BUILDING CODE OF AUSTRALIA AND ACCESSIBILITY COMPLIANCE ASSESSMENT REPORT

ALTERATION AND ADDITION TO A MIXED USE BUILDING AND A PUB

19-21 AND 23-29 THE CORSO, MANLY

REPORT NO. ► 11784.2 Rev 1.0

D3.3
Parts of the building required to be accessible

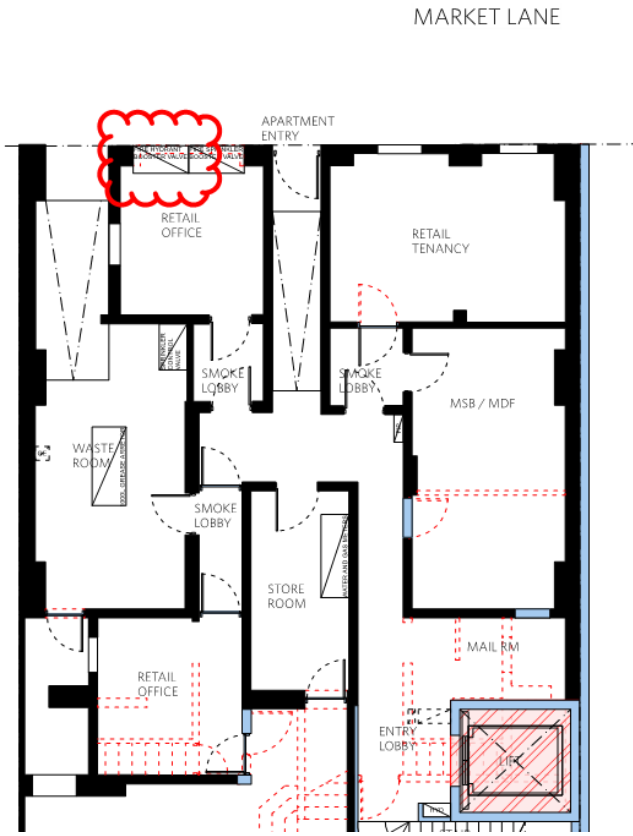
- 1st Floor to 3rd Floor - A turning space in accordance with Clause 6.5.3 of AS 1428.1-2009 is not provided at the end of the corridors serving the SOUs.

It is recommended that this is addressed by a Performance Solution at CC stage.

F4.2
Methods and extent of natural lighting

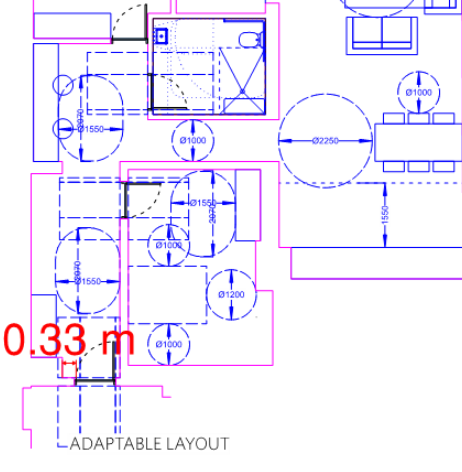
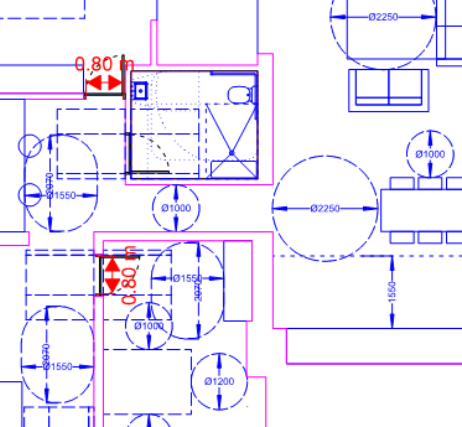
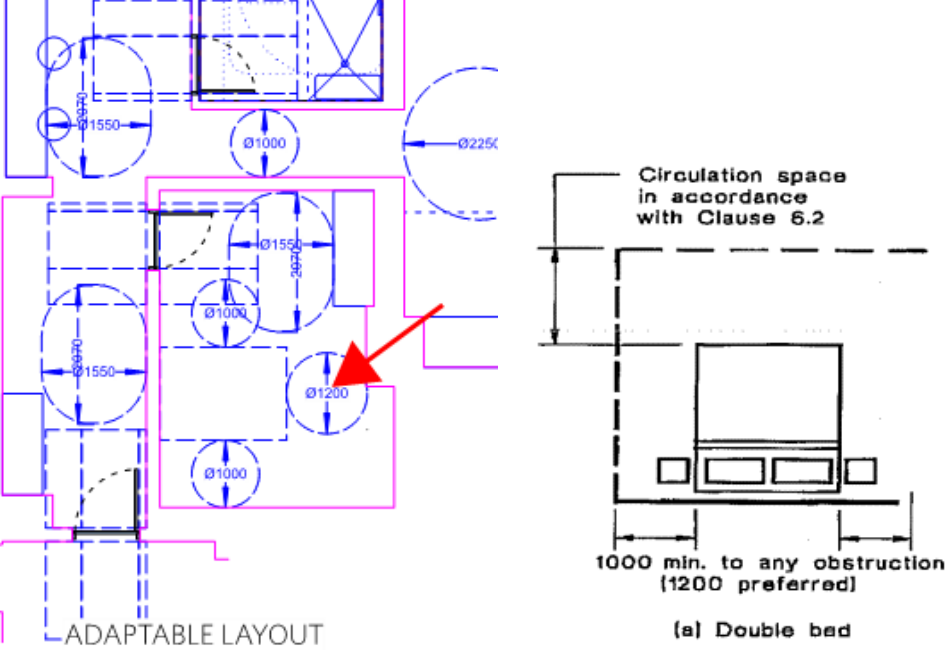
Level 1 - The bedrooms on the western side faces a boundary of an adjoining allotment and is less than horizontal distance from the wall which does not comply with (b).

Level	Calc (50% of square root of sill height)	Metres to wall	Complies
Level 1	$0.5 \times \sqrt{10.98\text{m}}$ = 1.66m	1.5	No.

It is recommended this is addressed by a Performance Solution at CC stage.

Figure 1: Current locations of boundaries (fire source features).

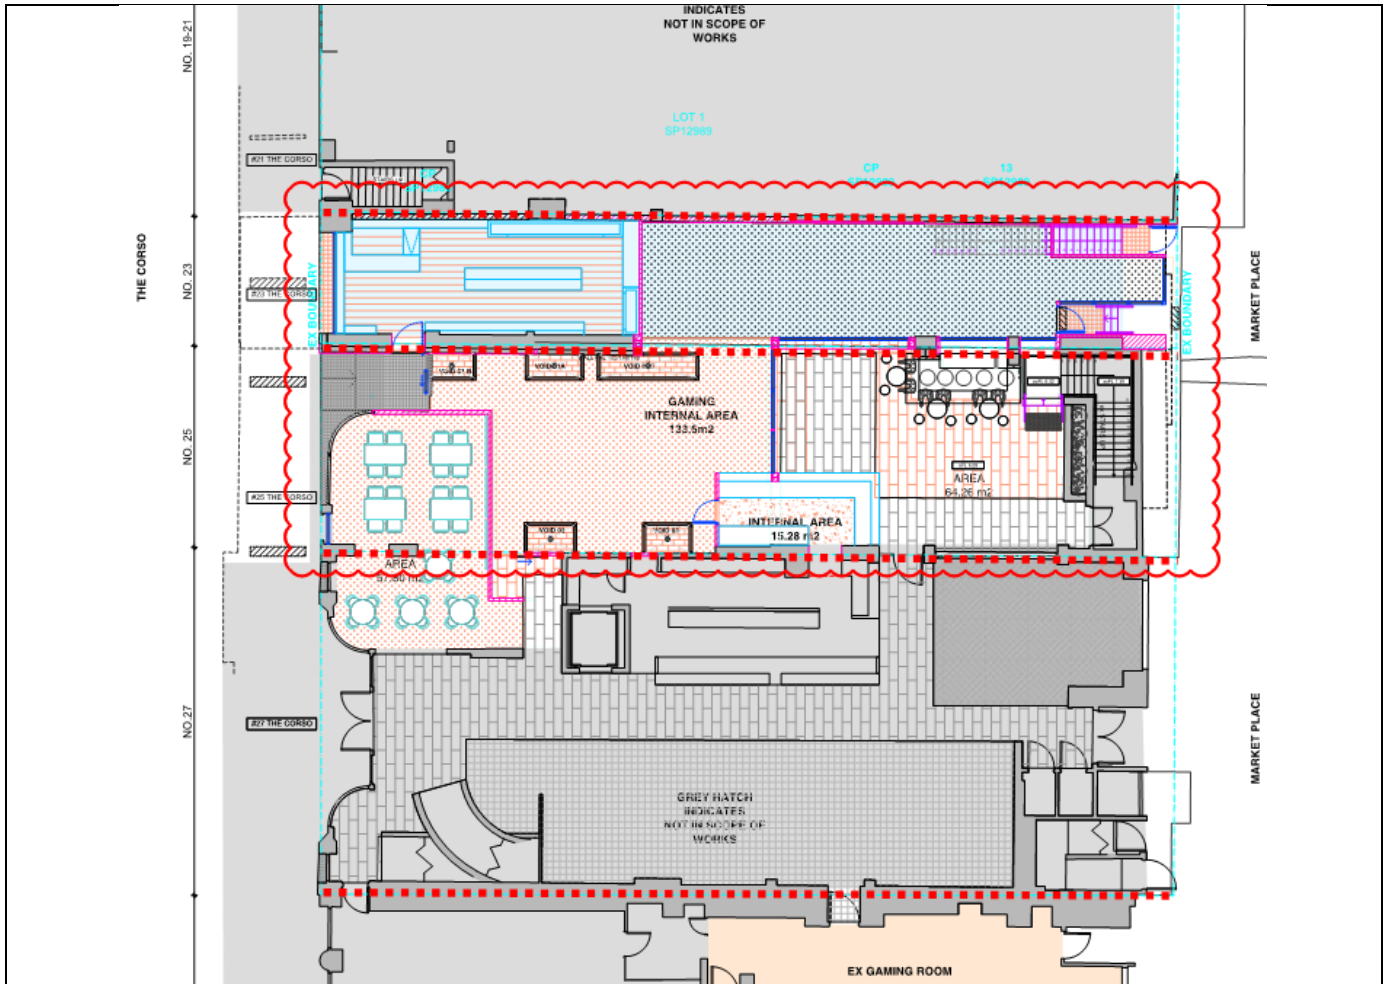
It is recommended the allotments are amalgamated so that *fire source features* no longer exist within the building and fire separation provision of BCA Clause C1.1 & C3.2 can be determined DTS compliant.
